Soils Report by E. M. Peto Assoc., Ltd.,  
Township Bridge #18, County of Lambton,  
Bridge Office Ref. #BA 1512.

Re: County of Lambton,  
Brooke-Warwick Townline,  
Lot 20, Con. VI, Warwick Twp.,  
Structure Site #15-114,  
Bridge Office Ref. #BA 1512.

The report on the soils investigation at the above site, submitted by the Consultant, R. M. Peto Associates, has been reviewed.

PROPOSED RECONSTRUCTION OF  
TOWNSHIP BRIDGE NO. 18  
COUNTY OF LAMBTON, ONTARIO.

SOIL SECTION THROUGH HOLES 2 & 1

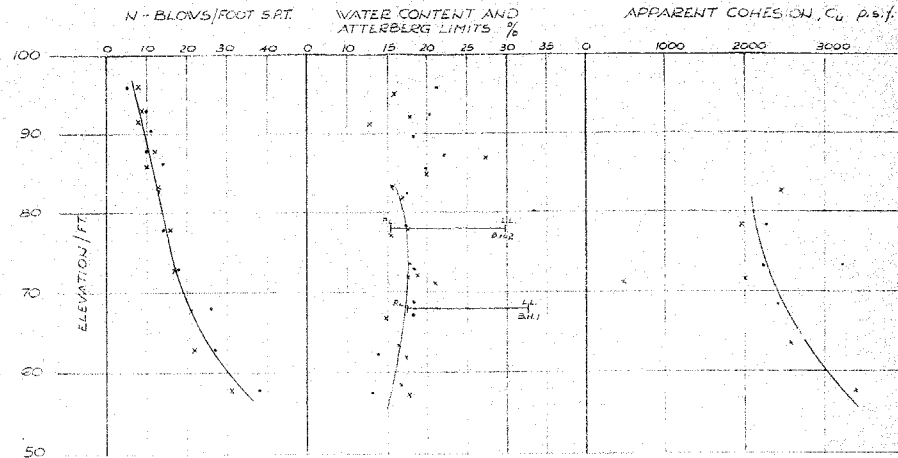
The load intensities are, as we know, the same. It suffices to glance at the drawing of the report showing the soil section through P.E. #1 and #2 to realize that one can hardly encounter more homogeneous subsoil conditions.
